Final
Technical Evaluation Report
for the Proposed Revised
Reclamation Plan for the Atlas
Corporation Moab Mill

Source Material License No. SUA 917
Docket No. 40-3453
Atlas Corporation

U.S. Nuclear Regulatory Commission

March 1997

Figure 2-1: Location map of selected Cenozoic faults and seismicity in Moab, Utah area. See text for explanation (from Wong, et al., 1996; by permission).

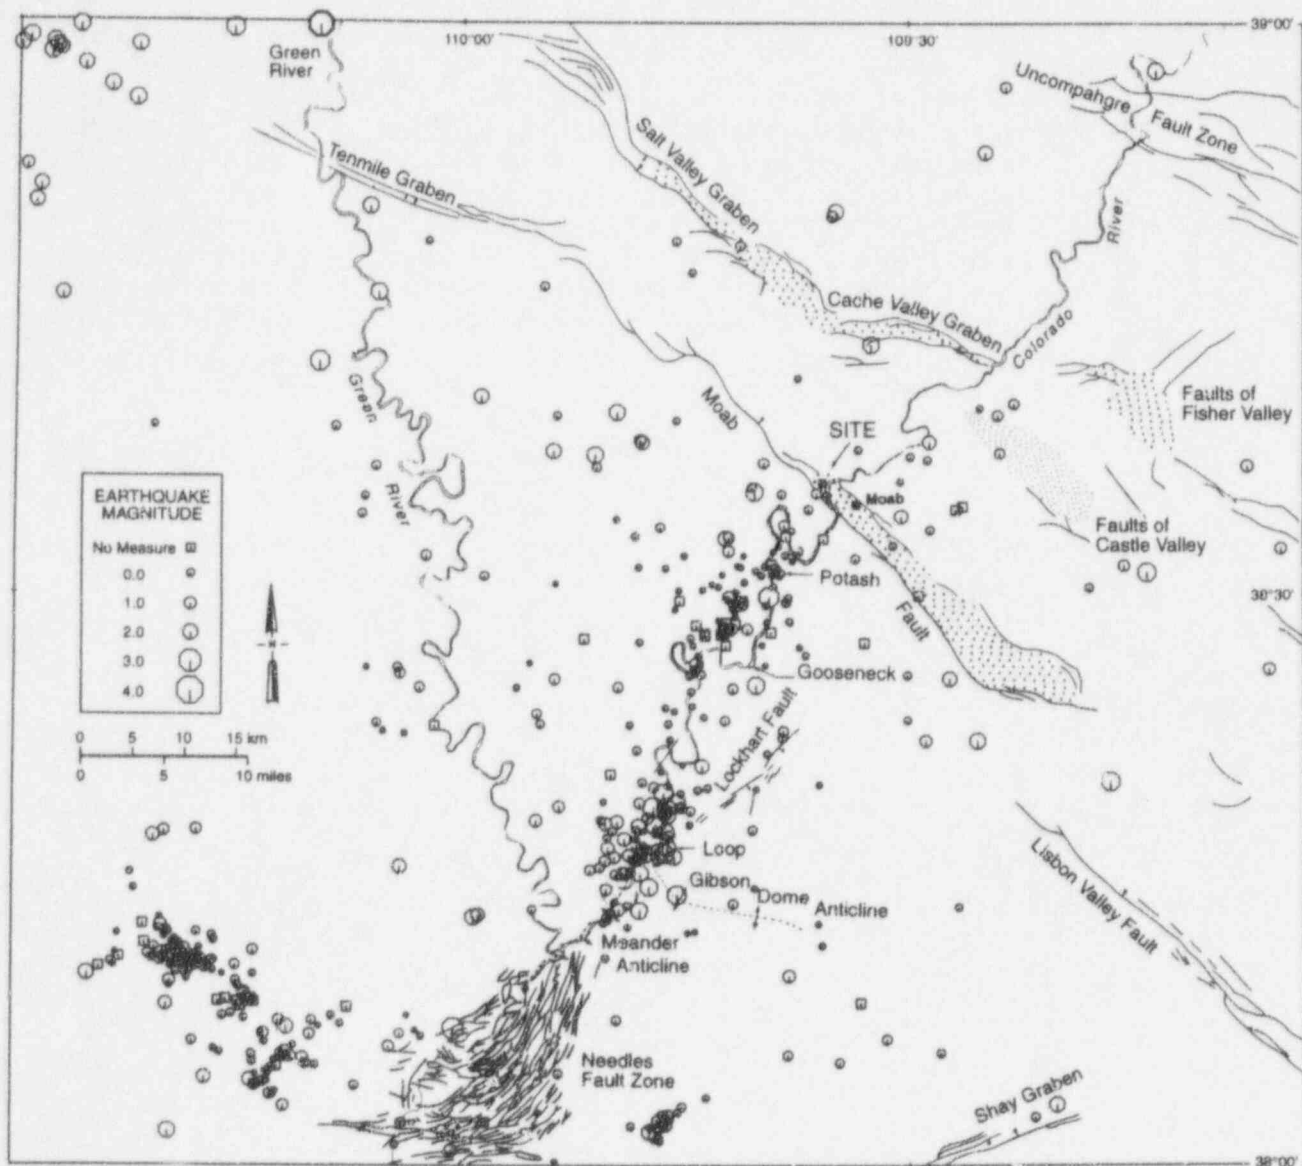
Figure 2-1 shows the general location of the Moab fault system and alignment of seismicity along an alleged basement fault. The Cenozoic faults are after Hecker, 1993. The seismicity includes records from 1953 to 1994 with possible induced seismicity associated with the Cane Creek mine at Potash omitted. Stippled areas represent distributed deformation; ball is on the downthrown side of normal faults (see Olig, et al., 1996; Wong et al., 1996). Figure 2-2 shows a conceptual relationship of the Moab fault, West Branch of Moab fault, Moab salt-cored anticline, Moab anticline and associated faults rooted in the salt-cored anticline, pre-Paradox Formation structure and Poison Spider Mesa escarpment with crest above 1.5 km (5000 feet).

The Paradox Basin structures have been considered to be compatible with a wrench tectonic system, and it has been suggested that part of the Basin is a pull-apart structure (Stevenson and Baars, 1986, 1987). From a regulatory perspective, the evidence for the existence of NW and NE basement faults is sufficient for concluding that an alignment of seismicity at basement depths may be correlated with such an otherwise unseen basement fault. This is the case for the NE-trending Colorado River seismic source which has been delimited in the Moab area (Section 2.4.3; Fig. 2-1).

Figure 2-2: Geologic cross section of Moab salt-cored anticline about 1 km north of Atlas site. West Branch and Moab faults are projected to underlie the Atlas site (from Doelling, et al., 1995, Plate 2; by permission).

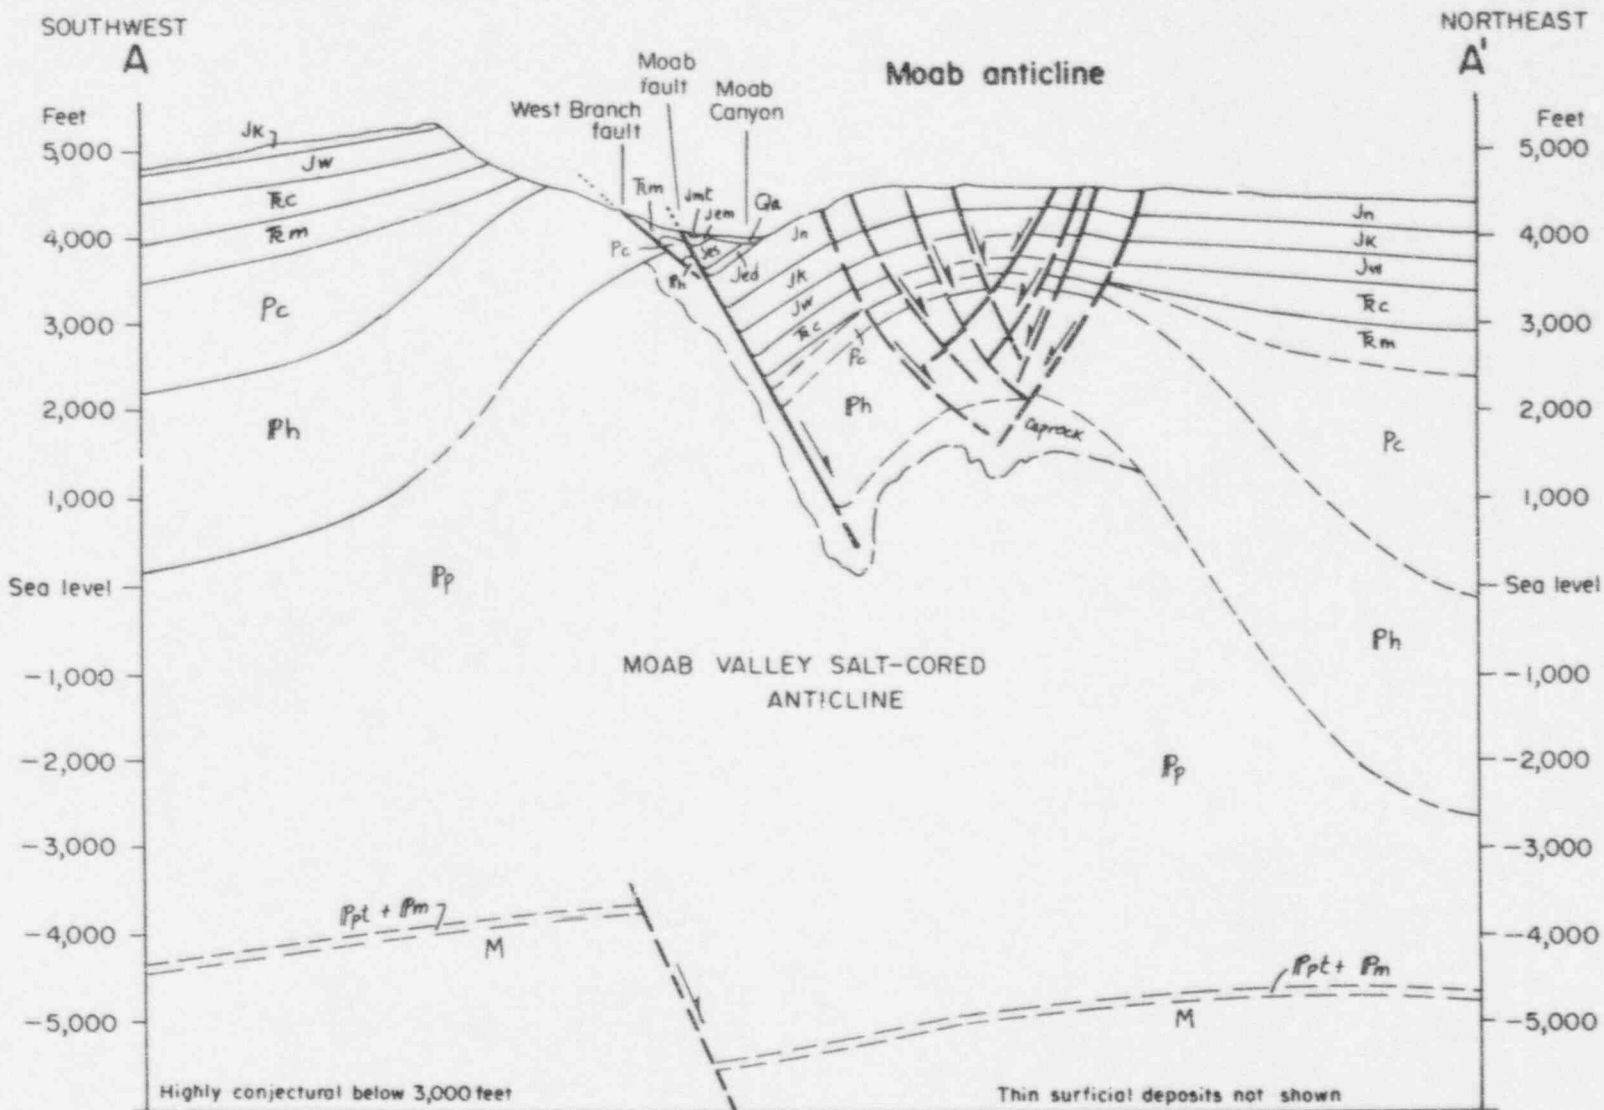
e.g., Moab (Fig. 2-2), Salt-Cache, Castle and Fisher Valleys. Other diapirs, like the Lisbon Valley salt-cored anticline, have a master fault(s) that penetrated cover rocks, e.g., the Lisbon Valley fault (Fig. 2-1), but have not sufficiently deformed the cover rocks or dissolved or flowed laterally to the extent necessary to initiate collapse of the cover rocks (Cater, 1970).

Figure 5-1: Monitoring Well Locations, Atlas Uranium Mill

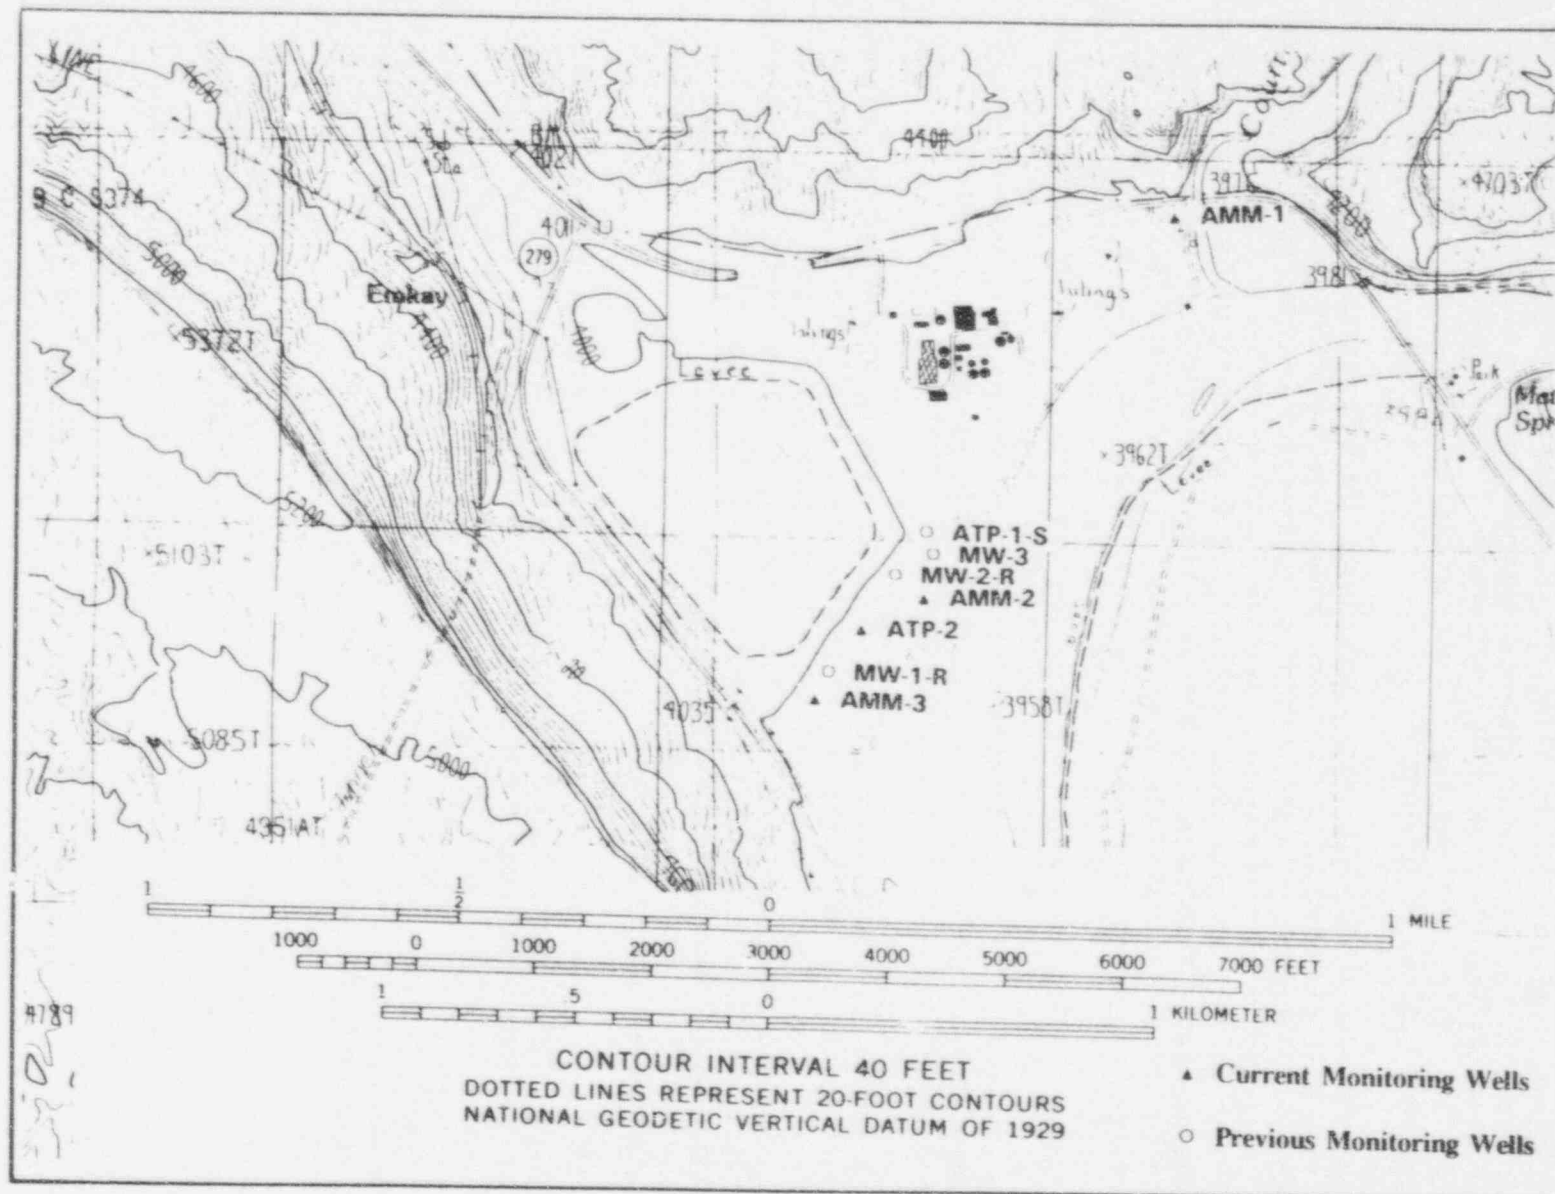
Well AMM-1 was established as the NRC-approved background well for the facility. The well is situated approximately at the far northeastern corner of the property, about 244 m (800 ft) northeast of the former mill area. Groundwater samples have been collected from AMM-1 since 1988 and show concentrations of selenium, combined radium-226 and -228 above the NRC maximum concentration limits (MCLs) and elevated concentrations of uranium. TDS concentrations in this well range from about 6500 to 7500 mg/L. Information submitted by Atlas (Harding Lawson Associates, 1996) depicts the cation and anion signatures of surface water and groundwater in the vicinity of the tailings pile. The information shows the TDS and major ion concentrations of various sampling locations at the Atlas site, the Colorado River, and the Matheson Preserve southeast of the site. The groundwater at AMM-1 is generally a sodium/chloride type water, while the tailings fluid is a sodium-magnesium/sulfate type water. Sulfate is the dominant anion of the tailings fluid and can be seen to influence the water quality in well AMM-2 southeast of the pile. Conversely, chloride is the dominant anion in the groundwater at AMM-1. This information strongly indicates that AMM-1 is likely unaffected by tailings seepage.

However, a review of site maps and historical aerial photographs of the site show a former ore storage pad situated about 61 m (200 ft) west of the background monitoring well location. Staff recognizes that placement of an upgradient, background monitoring well had previously presented technical challenges to the licensee, due to size of the milling area and the lack of sufficient groundwater in the previous upgradient well completed in the Moab Wash alluvium. Although the location for this well had previously been approved by the NRC, the licensee was requested to provide data showing that monitoring well AMM-1 is not influenced by contaminants from the former ore storage pad.

The staff reviewed the information provided by the licensee and does not agree that the provided information shows that well AMM-1 is not influenced by potential contaminants from the former ore storage pad. The licensee's explanation failed to consider two important influences. The characteristics of the tailings as a contaminant source are dramatically different than the characteristics of the ore as a potential contaminant source. The contaminant mobilities and concentrations within the tailings are greatly enhanced by the grinding and chemical processing of the ore. The milling and extraction process is designed to mobilize all metallic-ionic species, including uranium, and allow selective concentration of uranium. Once the tailings are placed in the impoundment, most of the remaining metal species appear to remain mobilized, as evidenced by contaminant concentrations in wells near the tailings.

While the tailings provides a ready supply of mobilized constituents, the ore would likely release constituents at a slower and more steady rate, influencing trace constituent concentrations but not overall major ion chemistries. Contaminants from the ore would be expected to enter the underlying soil and groundwater at a slower rate and less concentrated than those of the tailings pile. The licensee's conclusion that AMM-1 is unaffected by the ore pad, because the groundwater response near the ore pad is not like the response at the tailings pile is not valid, given the difference in the characteristics of contaminant sources.

Additionally, the licensee's conclusion concerning the groundwater flow direction fails to consider that there are few control points associated with the interpreted flow lines near the ore pad. Figure 1 provided in the licensee's response further confirms this observation by presenting the equipotential lines in this area as dashed. Much of the potentiometric information presented in the licensee's maps are interpolated from control points near the tailings pile and AMM-1. The groundwater flow in the vicinity of AMM-1 may be significantly affected by Courthouse Wash, causing localized groundwater flow in an easterly direction rather than a southerly direct as interpreted. The licensee shows a similar influence from Moab Wash in the provided potentiometric map as Figure 1.

The staff concludes that the information and interpretations provided by the licensee do not provide reasonable assurance that well AMM-1 is not influenced by potential contamination from the ore storage pad. Additional information and measurements at locations other than AMM-1 will be needed to corroborate the appropriateness of AMM-1 as a background well.

Figure 6-1: Reclaimed impoundment soil cover profiles, taken from drawing No. 88-067-A112, March 21, 1995 Atlas submittal

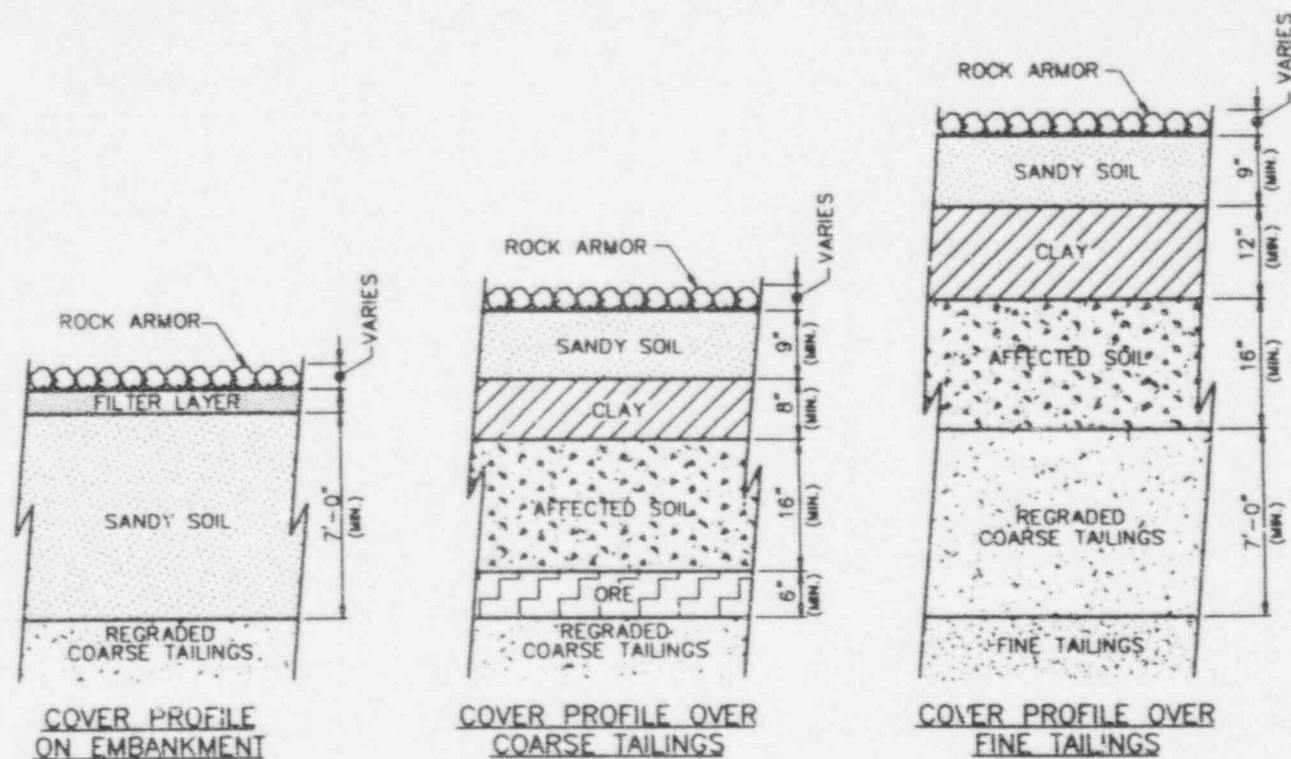
The cover system described above will provide a minimum of 37 inches of cover above tailings on the top and sides of the cell. The system has been designed to limit the infiltration of precipitation, protect the pile from erosion, and to control the release of radon from the tailings below. Details of the staff's review of the cover's performance related to limiting infiltration are addressed in Section 5 of this report; the review of the cover's erosion protection features is presented in Section 4, and the review of the radon attenuation aspects of the cover is presented in Section 6. Certain other design aspects of the proposed cover are discussed herein.

Tests on the compacted clay from Klondike Flats indicate that hydraulic conductivities will be near 10^{-7} cm/sec at placement conditions. In addition, the physical shape and surface grading of the reclaimed tailings embankment will effectively remove surface water resulting from precipitation which falls on the area. The relatively low permeability of the cover materials and the low annual rainfall with high evaporation rate will prevent significant tailings recharge.

The cover design has been evaluated by the staff for geotechnical long-term stability and the design is acceptable; however, it is required that the licensee perform materials testing during construction and revise the cover design if a need to do so is indicated at that time. The radon attenuation ability of the cover is discussed in Section 6 and the hydraulic conductivity aspects of the cover in Section 5.
